Re: Public Comments on WTC 7 Draft Reports

Chapter 9: Fire Simulations

Exhibit A
Graphical Examination of NIST
WTC 7 Floor 12 Fire Analysis

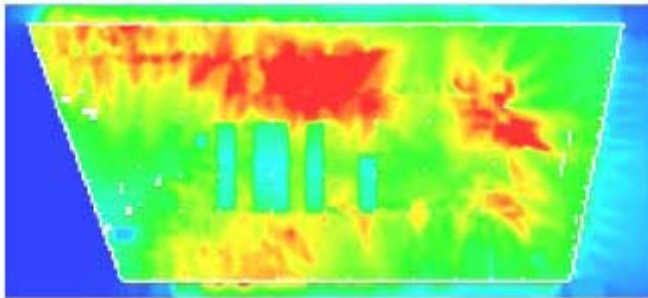
COMMENT: To support NIST’s assertion that there was indeed fire present on floor 12 at 5:00pm, NIST has provided a single photograph from an “unknown source” (Figure 5-152, NCSTAR 1-9, p. 237), that was purportedly taken at around 5:00pm, and shows fire in the two windows that comprise the northwest corner. NIST contends that it has determined that this photograph was taken at approximately 5:00pm, with a margin of error of “at least 10 minutes,” using shadow analysis.

REASON FOR COMMENT: We find it unlikely that NIST could estimate the time the “unknown source” photograph in Figure 5-152 was taken with such accuracy.

COMMENT: The following graphic is excerpted from Figure 9-11, and purports to describe the state of the fires on the 12th floor of WTC 7 at 5:00pm:

As can be seen, this graphic depicts raging fires across at least half of the north face of the building. However, when compared with Figure 5-152, which only shows a small fire in the extreme northwest corner, clearly the computer model is not representative of reality.

REASON FOR COMMENT: It appears that NIST's computer fire simulations are not representative at all of the fires actually occurring in WTC 7.

SUGGESTED REVISION: NIST must explain how it was able to estimate the photograph’s time using shadow analysis to a margin of error even close to 10 minutes.

SUGGESTED REVISION: NIST needs to describe why (assuming Figure 5-152 accurately describes the floor 12 fires at about 5:00pm) the computer models show significant fires across at least half of the north side of the building at 5:00pm. NIST should clearly explain why its fire simulation models of the 12th floor should be accepted by the public as an accurate representation of the fires actually occurring in WTC 7.

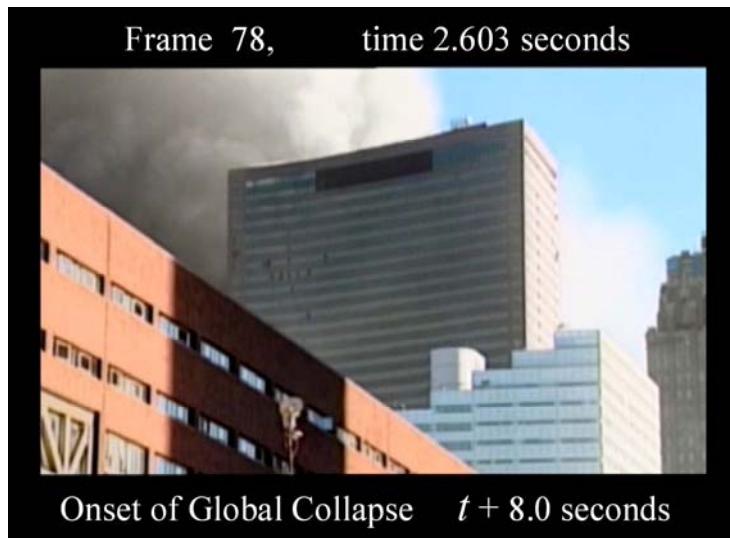
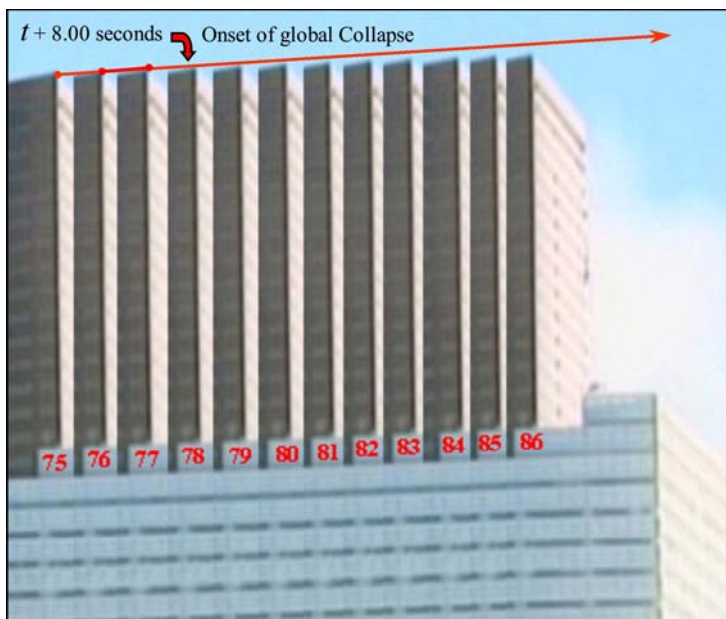
COMMENT: This comment concerns NIST’s estimation of the time it took for the WTC 7 structure to fall. Specifically, this concerns NIST’s comparison to the actual descent time with a hypothetical free-fall time. (NCSTAR 1-9, p. 595; NCSTAR 1A, p. 40-41) Basically, NIST took two data points, and assumed a constant acceleration throughout the collapse. (Id.) The first data point was allegedly taken at the time the top of the parapet wall on the roofline of the north face began descending. The second data

point was allegedly taken at the time the roofline was no longer visible in Camera 3. NIST claims that the time it takes for the building to fall this distance, 242 feet, is 5.4 seconds, plus or minus 0.1 seconds. No graphical or visual support is given for this time estimate.

REASON FOR COMMENT: Members of this group have conducted an independent analysis of the Camera 3 footage and come to an entirely different conclusion regarding the collapse time. Our analysis was done on a frame-by-frame basis using a frame rate of 29.97 frames per second. As shown in the figure below, our analysis concludes that it takes 3.87 seconds for the top of the roofline to descend out of view of Camera 3. This time matches almost exactly the free-fall time.

SUGGESTED REVISION: NIST must revise its Report to show the exact frames it used from Camera 3 in determining the time it took for the roofline to fall out of view. 5.4 seconds appears to be a gross overestimate. The frames we used in our collapse analysis are shown below (times “t + X seconds” reference the times given in NIST’s Appendix L, Table L-1) along with a graphical analysis of how we determined which frame represented the onset of global collapse:

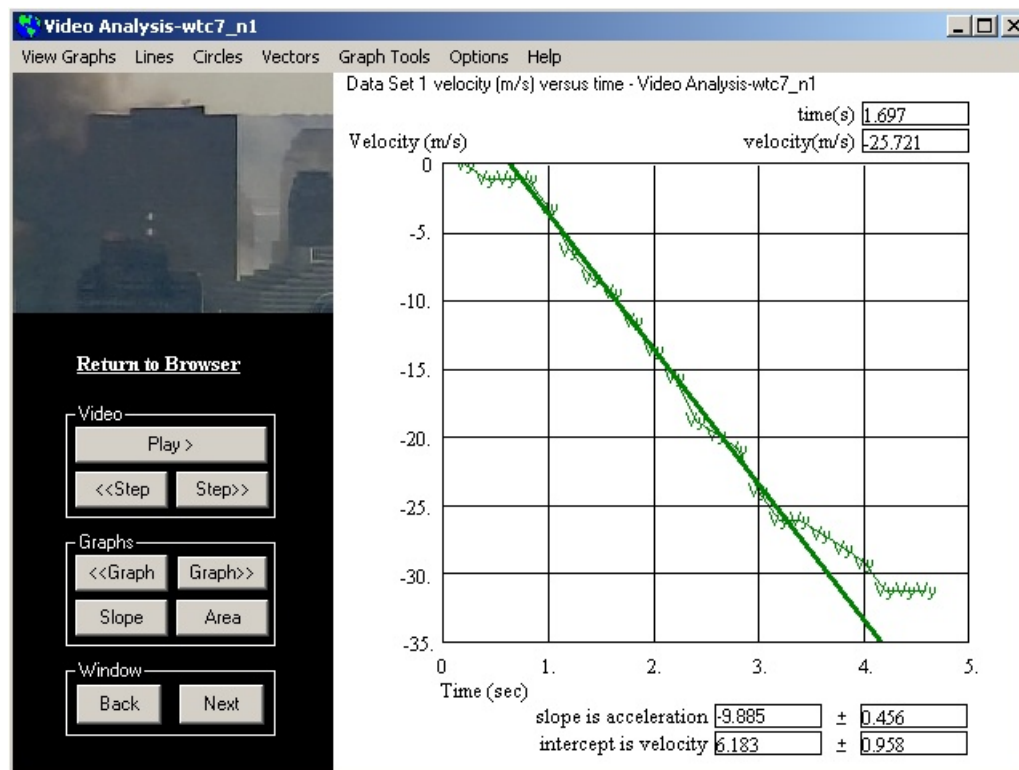
Members of this group have used the Physics Toolkit computer software to plot Velocity vs. Collapse Time using discrete data points gathered during the entire collapse from the view NIST calls Camera 2. This plot is reproduced below and provides a much more detailed look at the dynamics of the WTC 7 collapse than is provided by NIST's two-data-point analysis. Also included in the graph is a linear regression for approximately 2.6 seconds of the collapse that appears to have a constant acceleration. As can be seen, the slope (acceleration) during this portion of the collapse was approximately constant at about 9.8 m/s/s, or acceleration due to gravity with little to no resistance below. The r-squared value for this linear regression analysis was 0.9931 – a very good fit. This clearly demonstrates that NIST is being extremely misleading in reporting to the public that the structure did not descend at free-fall speed, especially given the implications of this documented feature of WTC 7's destruction.

Architects and Engineers for 9/11Truth
Submitted by Chris Sarns
Progression of fire on Floor 12 of WTC 7
(consistent with photographs)

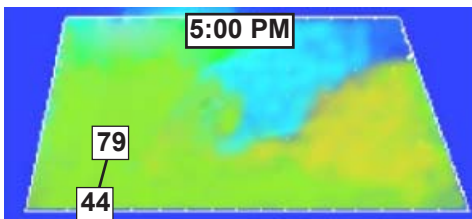
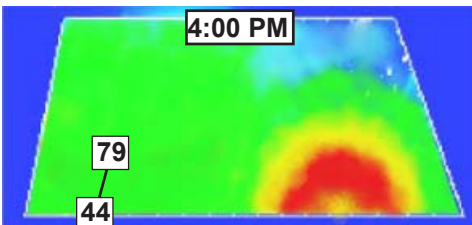
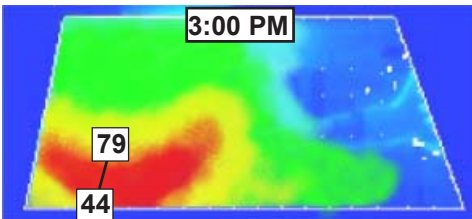
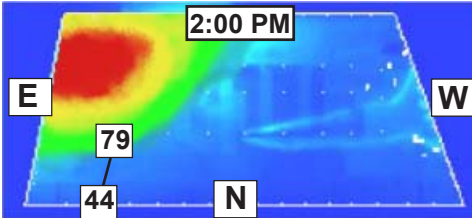
On page 383 of NIST NCSTAR 1-9 Vol. 1 (2008), the fire simulations graphic of floor 12 shows the fire burning around column 79 at 4:00 and 5:00 PM. The NIST simulation is not consistent with the photographs of the fire. The photographs show, and the NIST Appendix L report (2004) states “Around 4:45 PM, a photograph showed fires Floors 7, 8, 9, and 11 near the middle of the north face; Floor 12 was burned out by this time.” In fact, it had burned out in the east end before 4:00 PM.

NIST NCSTAR 1-9, Vol. 2, page 383
Figure 9-11. Progression of simulation
fire on Floor 12 of WTC 7.
(NOT consistent with photographs)

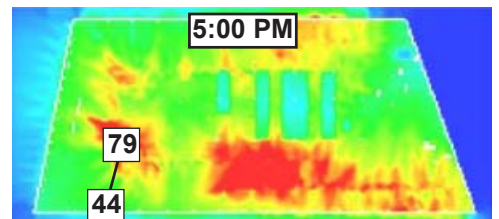
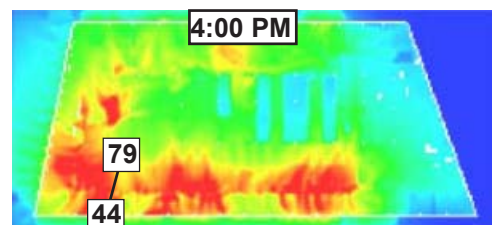
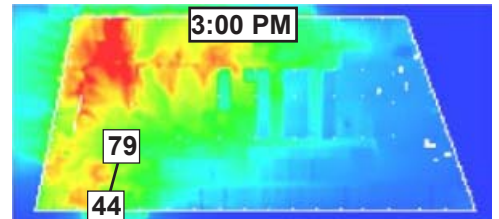
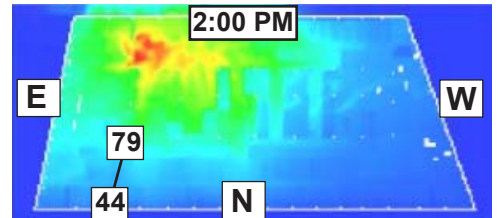
According to NIST, the fire on floor 12 caused the girder between columns 79 and 44 under floor 13 to fail at 5:20 PM. Theoretically, this was the beginning of the initiating event that led to the implosion of WTC 7.

Therefore, the fire on floor 12 could not have caused floor 13 to collapse (at 5:20 PM) and the implosion of WTC 7 could not have occurred as NIST has proposed.
